Service Bulletin

PRELIMINARY INFORMATION

Subject: Click Rattle Or Squeak Noise From Dash Area

Models: 2015 - 2016 Cadillac Escalade Models
2014 Chevrolet Silverado 1500
2015 - 2016 Chevrolet Silverado, Suburban, Tahoe
2014 GMC Sierra 1500
2015 - 2016 GMC Sierra, Yukon Models

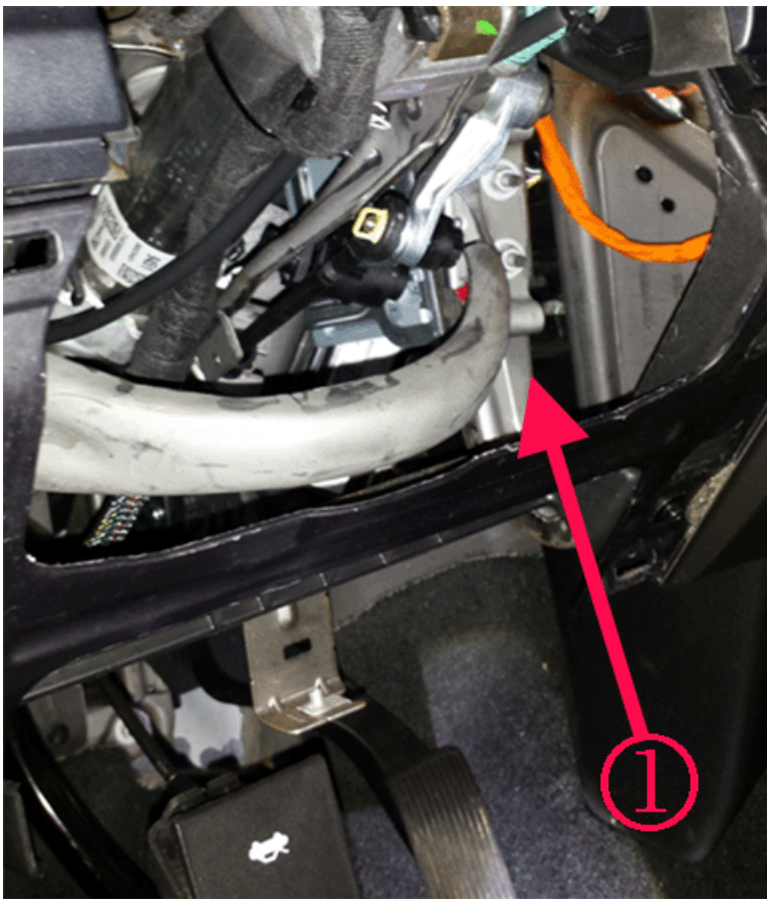
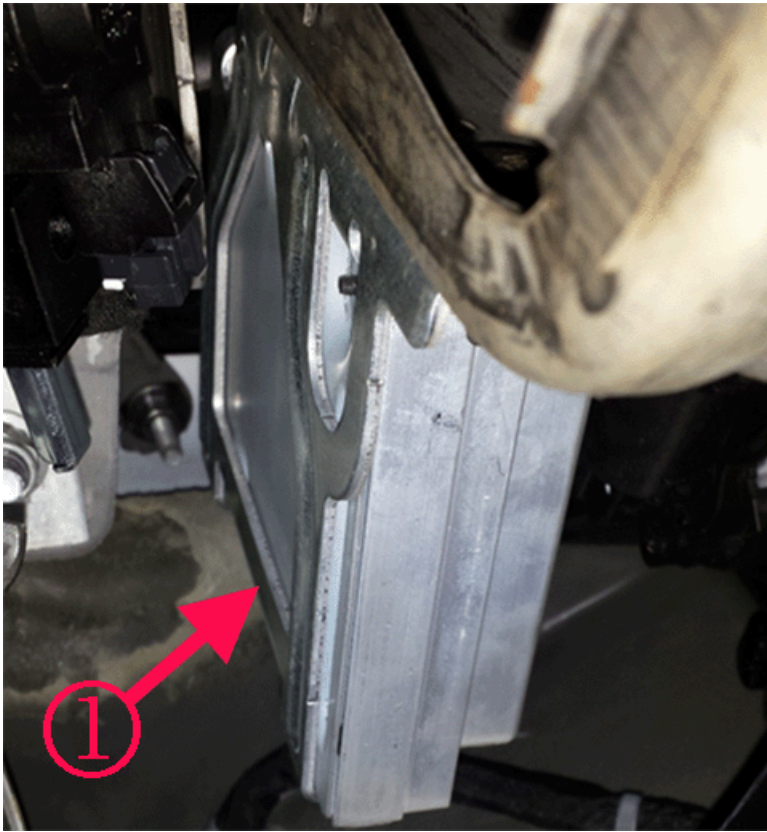
Condition 3: A rattle or itch type noise from the dash area near the windshield

Defroster grill may be rattling due to insufficient retention of retainers. Press on defroster grill (# 1 in illustration) while duplicating concern to see if it is eliminate

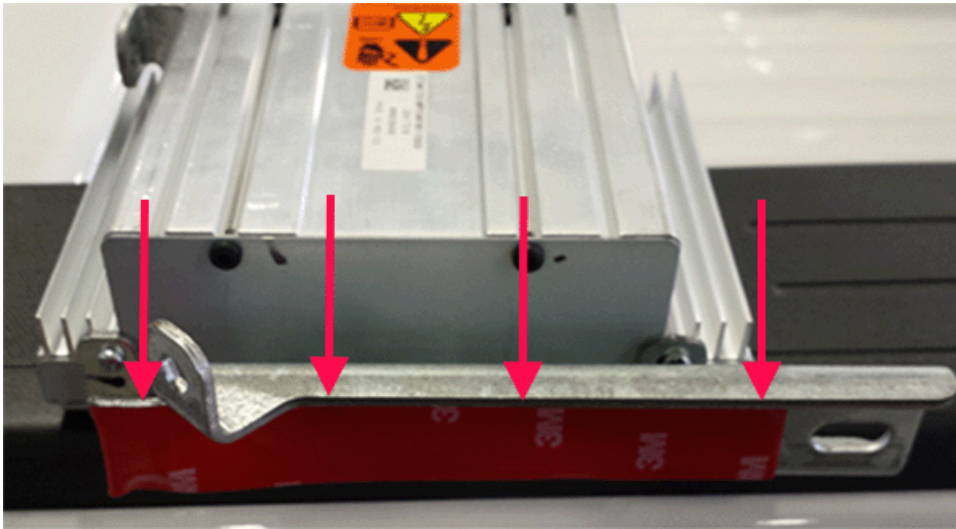
Correction 1 (for vehicles equipped with 110 Volt AC Converter - RPO K14):

Follow SI to locate the Accessory AC and DC Power Control Module located to the right of the steering column.

See #1 in photos below:

Inspect the power inverter module for possibly moving slightly against mounting bracket and creating the noise.

Remove the K14 power inverter module and apply two-sided tape to the module bracket to insulate it from the mount.

Two sided tape is available through Kent Automotive, part # P40519 which is a ½"x 50' roll or it may be obtained locally.

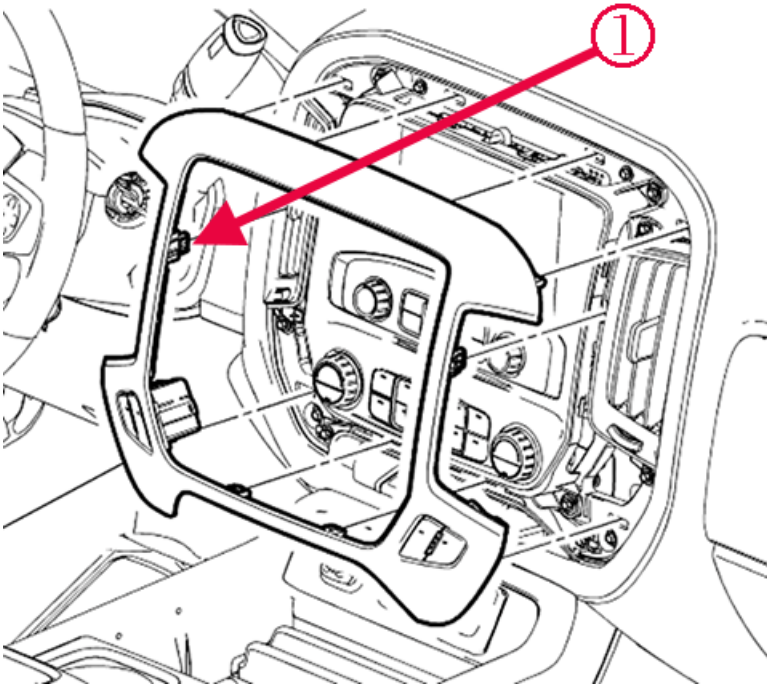
Correction 2:

Wrap Kent automotive BRS flocking tape part number KT13487 over retainers (#1 in illustration) and reinstall bezel.

This will require an application of BRS flocking tape on ten retainers (one strip @ 1" x 10"). Two sheets should repair 16 vehicles

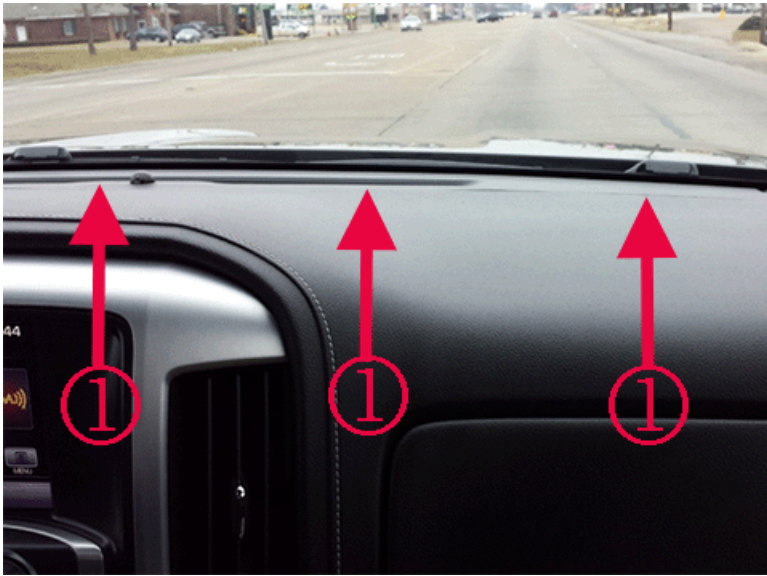
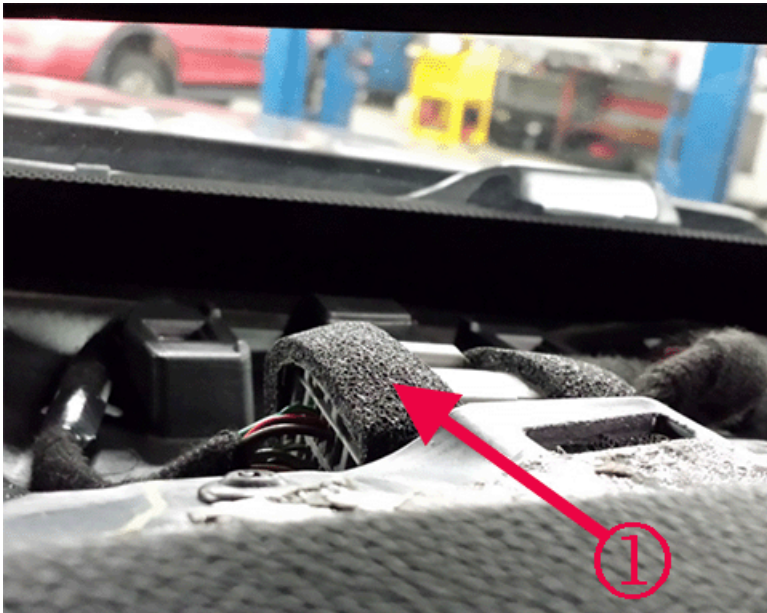
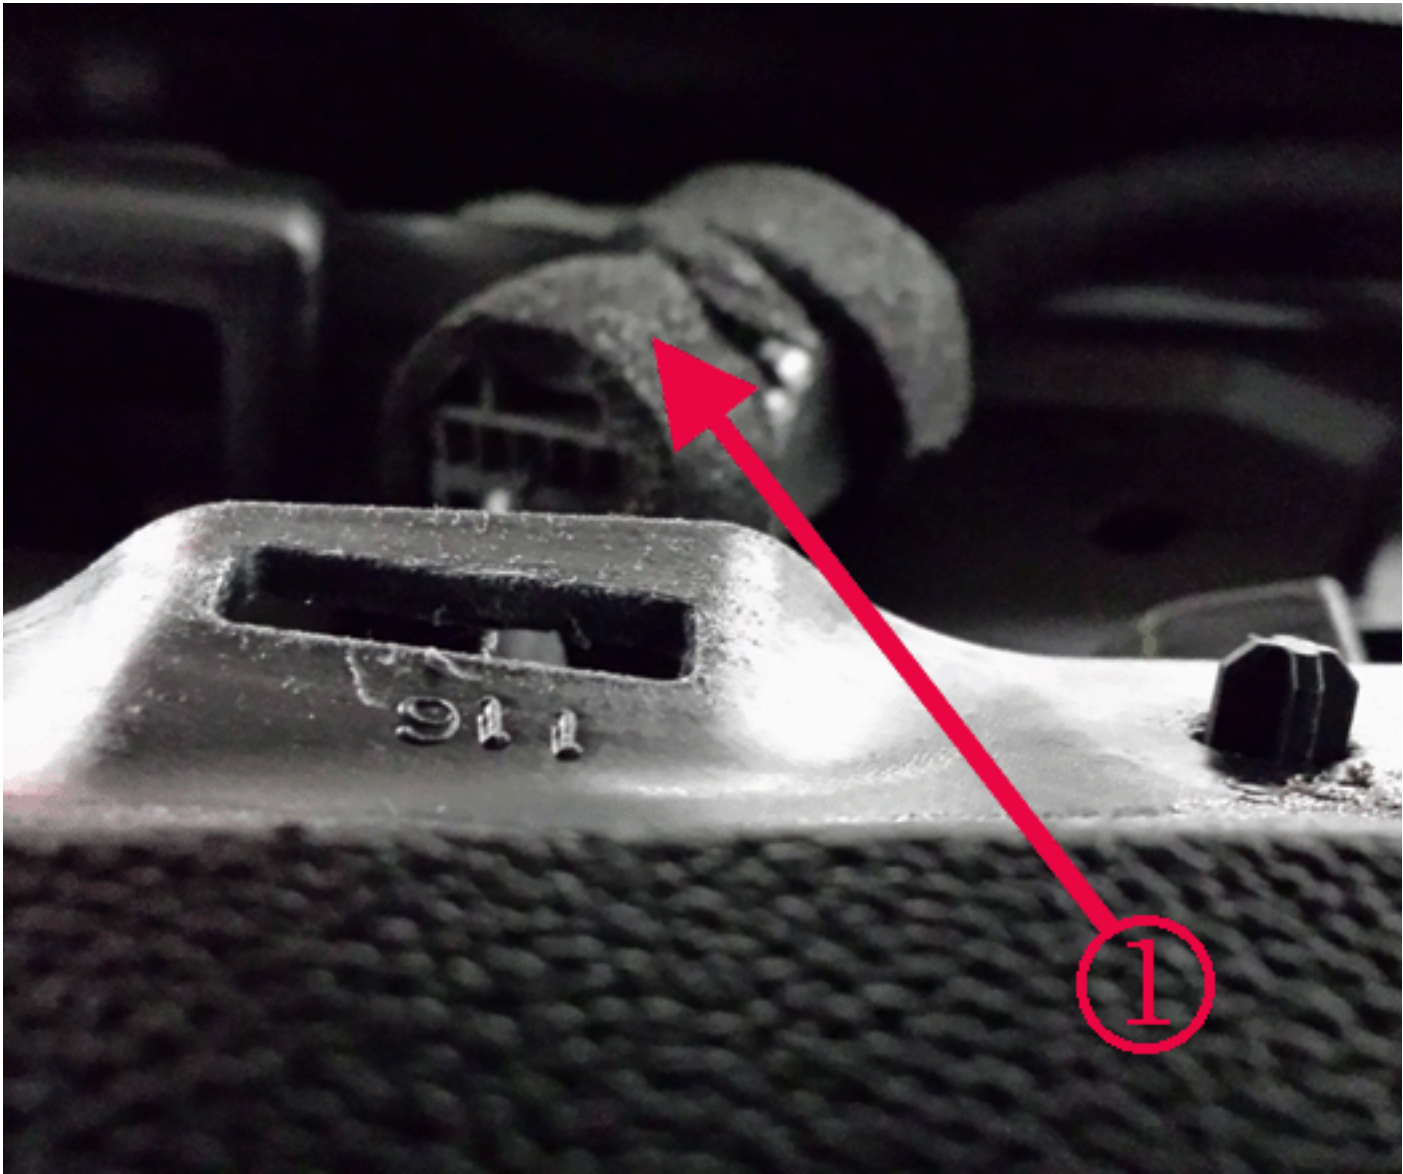
Correction 3:

Remove defroster grill.

Apply foam tape around connectors located under grill to prevent them from rattling on grill. See # 1 in illustrations.

Apply foam tape to all mounting hooks in the front of the defroster grill # 1 and apply a strip of foam tape along the edge of the grill to isolate the grill from the dash #2.
